BUILDINGS ORDINANCE (Chapter 123)
(Section 35)

BUILDINGS ORDINANCE (CAP. 123)
Order by the Building Authority under section 24(1)

Order No.: UBCSN/14-58/0001/11	Office of the Building Authority 12/F - 18/F., Pioneer Centre, 750 Nathan Road, Mongkok, Kowloon.
BD Ref. : EB/4150/61/T05W(COURSE-CR/11)	
To : All owners of No.32 and No.34 Li Tak Street, Kowloon	Date: 15 July 2016

Owner(s) of the premises at: No.32 and No.34 Li Tak Street, Kowloon

Ground Floor Plan

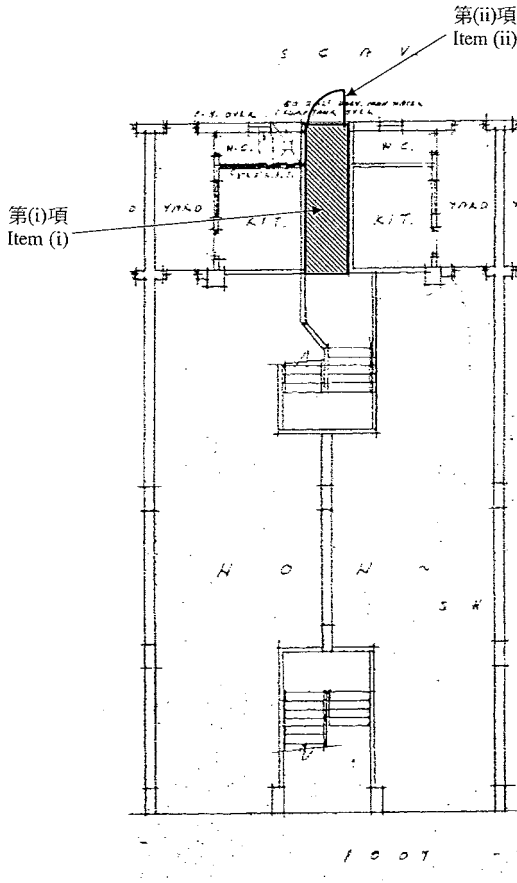
- (i) 1 canopy above the corridor leading to rear lane on G/F; and
- (ii) 1 lockable metal gate at the entrance facing rear lane on G/F.

2. For the said building works:
 - (a) The building works at items (i) above have been carried out without having first obtained from me the approval of building plans and consent for the commencement of such building works required by section 14 of the Buildings Ordinance.

- (b) As a result of the building works at items (ii) above, Regulation 41(1) of the Building (Planning) Regulations, which require the building to be provided with such means of escape in case of emergency as required by the intended use of the building, has been contravened.

命令中所指的項目第(i)及(ii)項

Items (i) & (ii) as referred to in the order

3. In exercise of the powers vested in me under section 24(1) of the Buildings Ordinance, I hereby order you to :-
 - (a) demolish the said building works described under items (i) to (ii) above; and

- (b) reinstate the parts of the building so affected by the building works under items (i) to (ii) above in accordance with the plans approved by the Building Authority.
